BID ADDENDUM NO. 2

March 30, 2026
Elmira City School District
Elementary Schools 2026 Renovations
HUNT No.: 2012-255

The following Addendum items shall be considered a part of the contract documents prepared by HUNT ENGINEERS, ARCHITECTS, LAND SURVEYORS & LANDSCAPE ARCHITECT, DPC.
Bid Document date of **December 12, 2025**; Issued For Bid **February 25, 2026**.

1 SECOND FLOOR DEMOLITION PLAN - AREA A
1/8" = 1'-0"

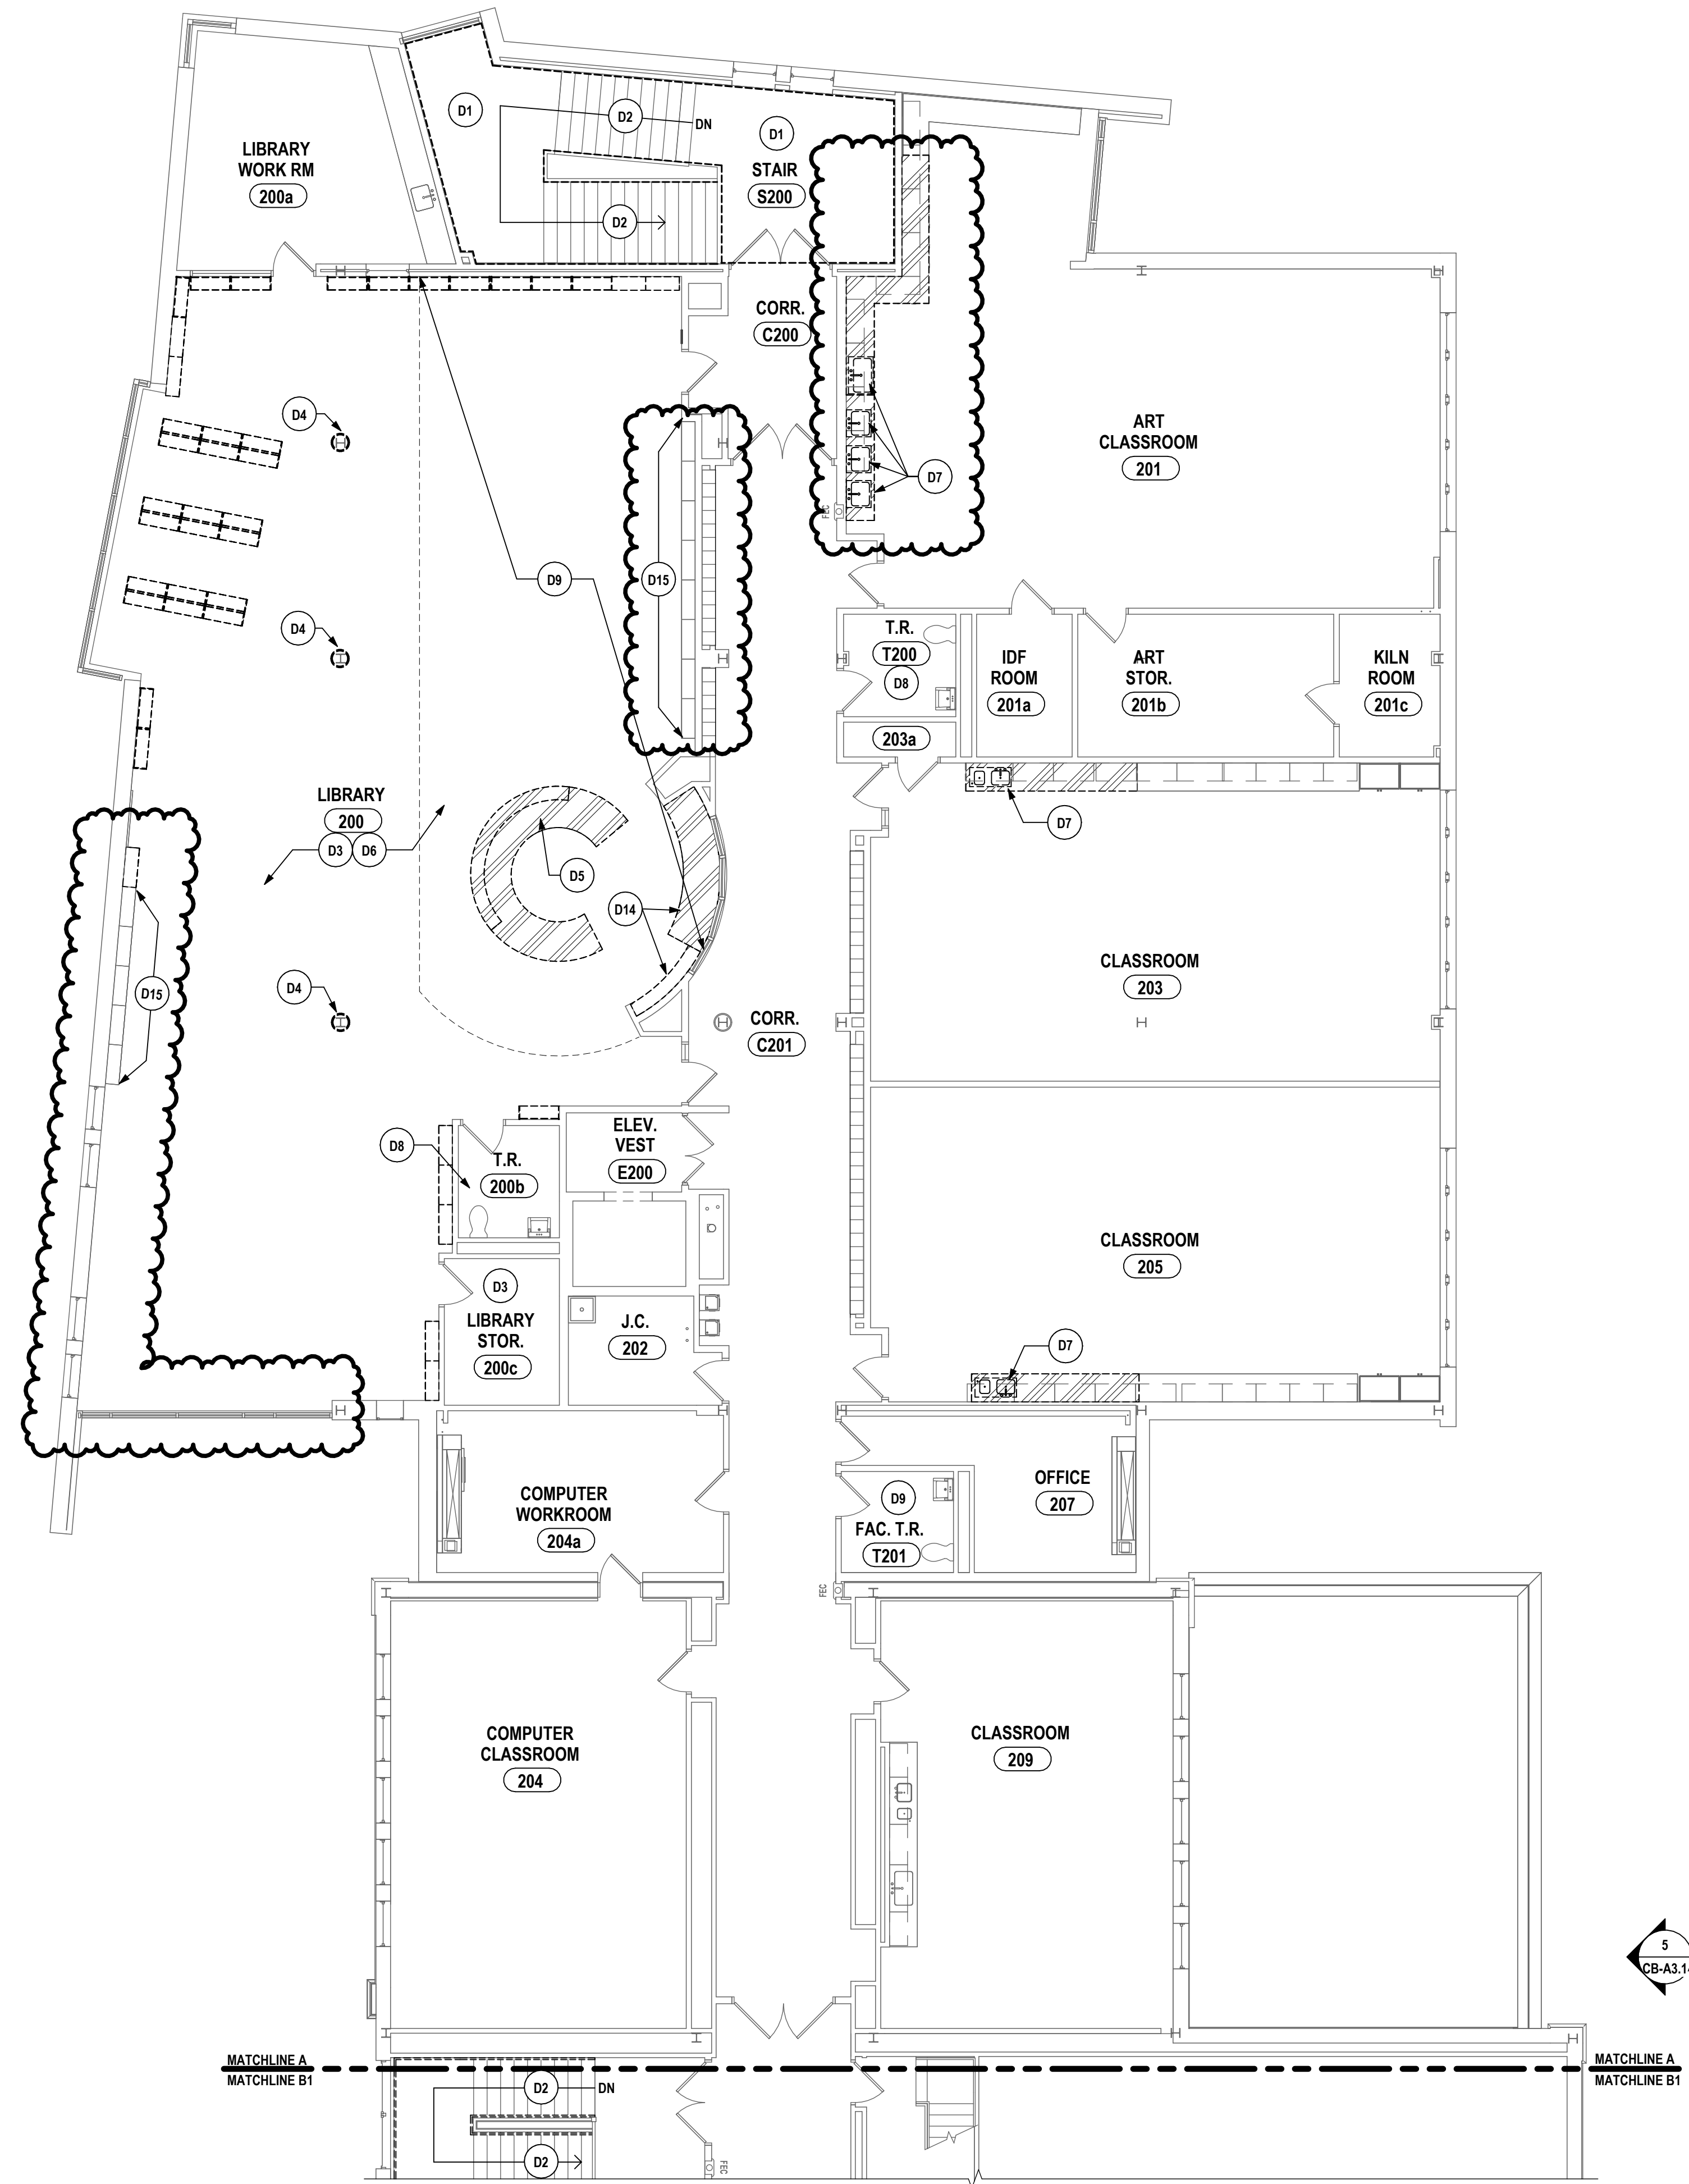
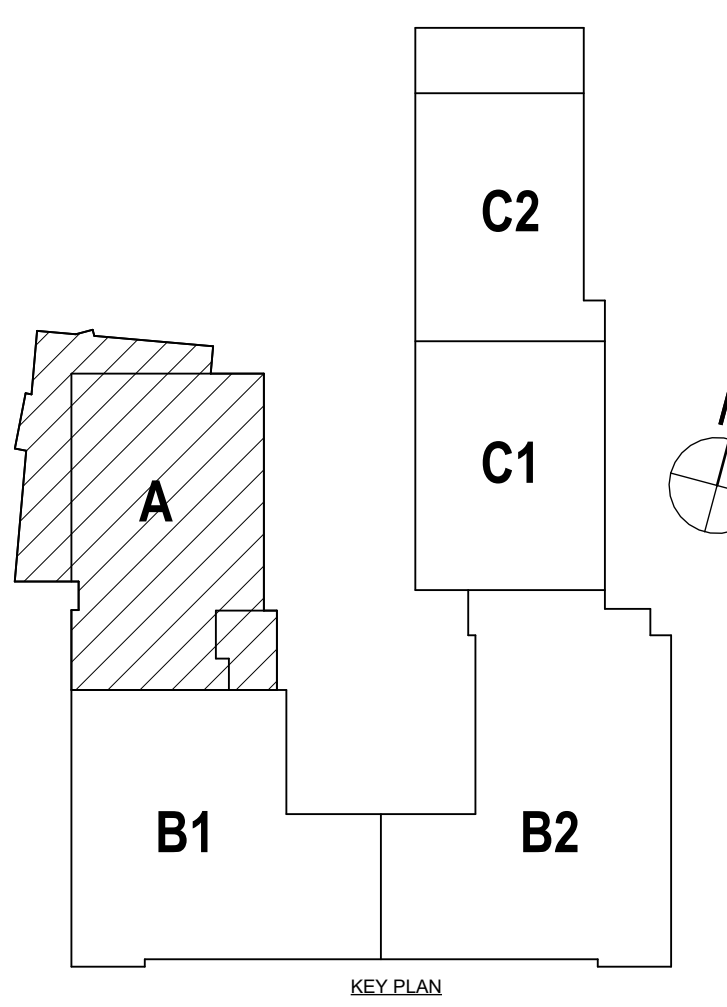
ITEM AD2-30 Refer to CB-A0.7 – SECOND FLOOR DEMOLITION PLAN - AREA A

AMEND Note D5 to read as “REMOVE BUILT-IN LIBRARY CIRCULATION DESK & ACCOMPANYING SOFFIT IN THEIR ENTIRETY.” in lieu of “REMOVE BUILT-IN LIBRARY CIRCULATION DESK IN ITS ENTIRETY.”

ADD Note D14 to read as “REMOVE COUNTERTOP IN ITS ENTIRETY.”

ADD Note D15 to read as “EXISTING CASEWORK TO REMAIN.”
